REGIONAL REVIEW NOTICE

ARC REVIEW CODE: R1004051

Name of Proposal: North Point Community Church – Sugar Hill

NORTH POINT COMMUNITY CHURCH SUGAR HILL DRI
City of Sugar Hill
Environmental Planning Division Review Comments
April 6, 2010

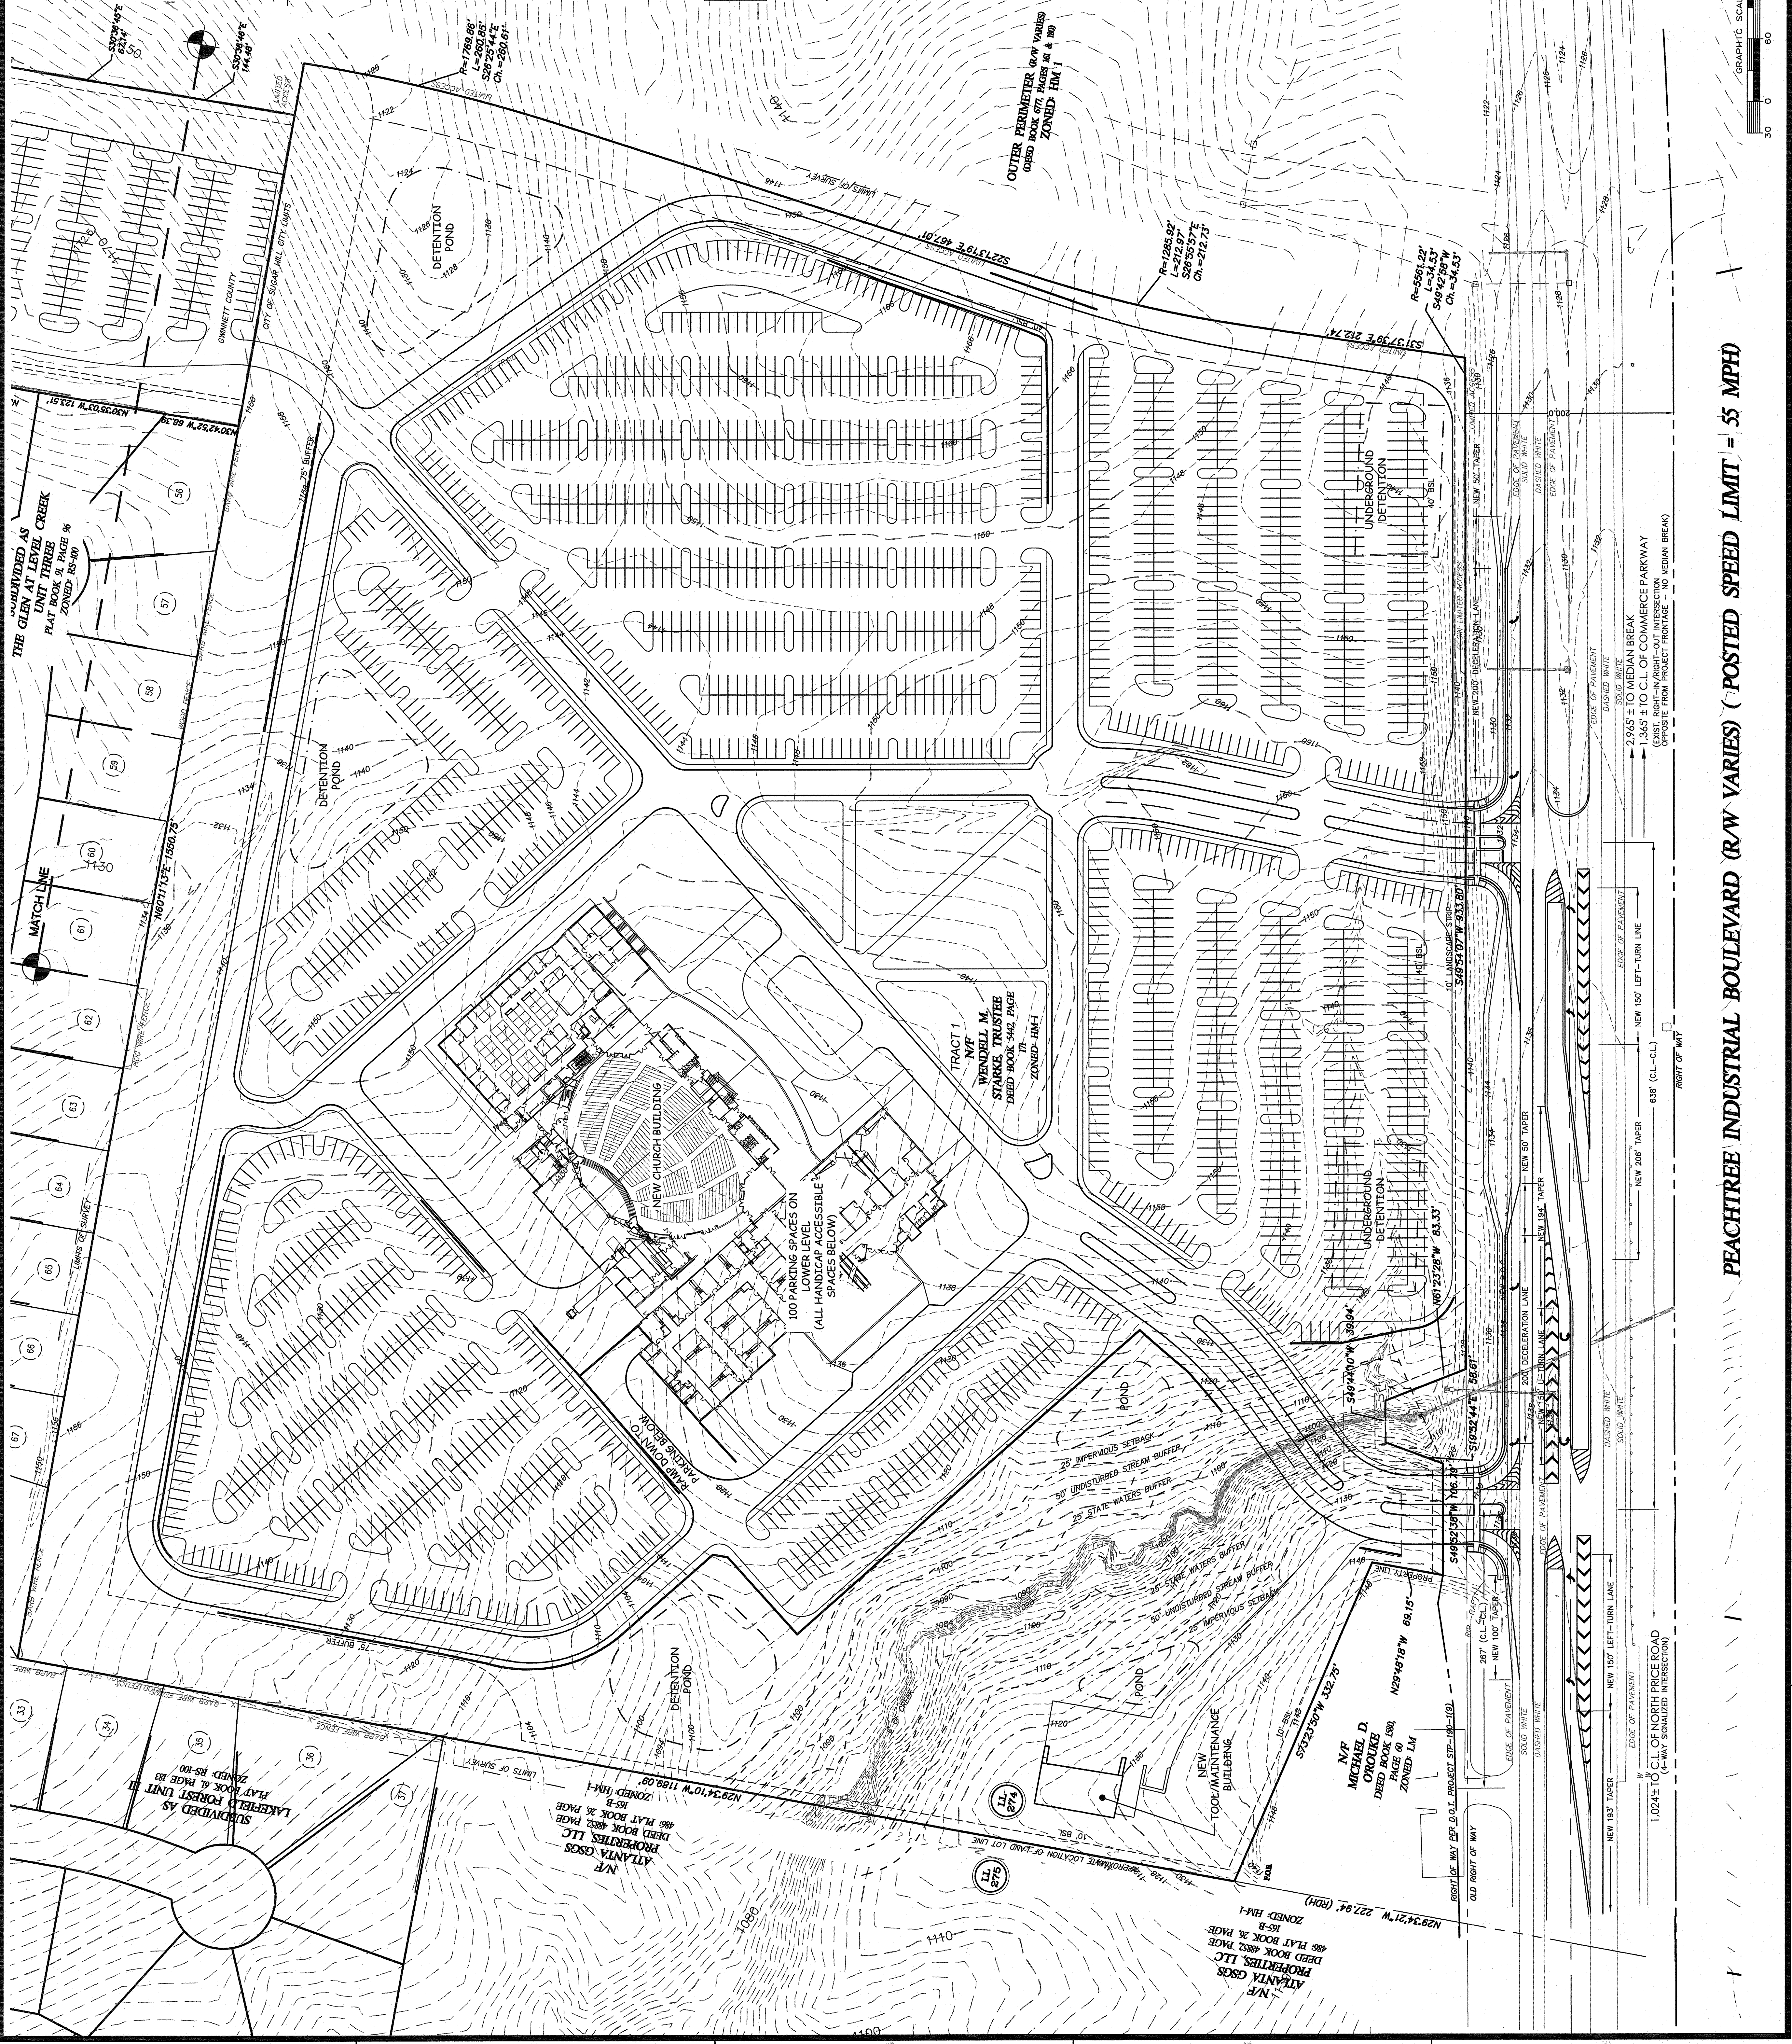
ARC staff has concerns with the proposed driveways and median breaks. The proposed development is located along Peachtree Industrial Boulevard (SR 141). Currently, there is one median break along the frontage of the proposed development's property. The site plan shows two driveways on Peachtree Industrial Blvd with median breaks that are approximately 638 feet apart. ARC staff has concern over the spacing of these breaks and whether or not two median breaks are warranted. The developer should investigate having one driveway use the existing median break and the second driveway function as a right-in/right-out.

The Georgia DOT Driveway Manual designates a minimum median crossover distance of 1320 feet, and a preferred distance of 2640 feet, on rural median-divided state highways (GDOT Driveway Manual, p. 33). It appears that the proposed median spacing violate the GDOT minimum since Peachtree Industrial Boulevard is a state highway. ARC staff needs clarification from GDOT staff on this matter.

ARC staff has concerns over the amount and placement of the parking. The City of Sugar Hill requires 1 parking space per 4 seats. In the case of the proposed development, that would equal 750 parking spaces. The site plan shows 2,435 parking spaces, well above what is required. The developer should reduce the amount of parking to avoid having large fields of unused, impervious surface parking, especially when the building is not fully occupied during the weekdays.

The parking that remains should be screened from view and the building should be brought closer to the street. This can help reduce the visual impact of the large amounts of parking on both the surrounding neighborhoods as well as from Peachtree Industrial Blvd.

spacing between the two median breaks will be 638 feet. Georgia DOT Driveway Manual designates a minimum median crossover distance of 1320 feet, and a preferred distance of 2640 feet, on rural median-divided state highways (GDOT Driveway Manual, p. 33). It appears that the proposed median spacing violate the GDOT minimum since Peachtree Industrial Boulevard is a state highway.

The ARC Transportation Planning staff would advise that only one of the driveways be allowed a median opening, with the other driveway operating as a right-in, right-out driveway only. This would minimize the traffic conflicts imposed by the DRI, and protect the mobility along Peachtree Industrial Boulevard. Due to potential future median opening at the intersection with Commerce Parkway (currently lacking a median opening; a right-in, right-out intersection), it would be advisable to retain the median opening furthest away from Commerce Parkway (already existing), and to eliminate from the plans the median opening nearest to Commerce Parkway.

- Consider the throat length for the north-most driveway: the length should be at least 200 feet, prior to allowing right or left turns into the parking lot. From the site plan, the distance appears right at 200 feet or slightly shorter. If the distance is shorter, amend the plan to allow sufficient throat length.

A stream is shown running across the southwestern corner of the property. The submitted plans show both the State Sediment and Erosion Control 25-foot buffer and the City's 50-foot stream buffer (which overlaps the state buffer) and its additional 25-foot impervious setback. The USGS coverage for the project area shows a blue line tributary to Level Creek near the southeastern corner of the property. If any portion of the stream or its buffer area extends onto the project property, those buffers will need to be shown.

- Build deceleration lanes as proposed for the two driveways
- Build left-turn lane and u-turn lane as proposed at the south-most (existing) median opening

- Allow two driveways, but only one median opening (retaining the existing median opening), such that the north-most driveway would operate as a right-in, right-out driveway
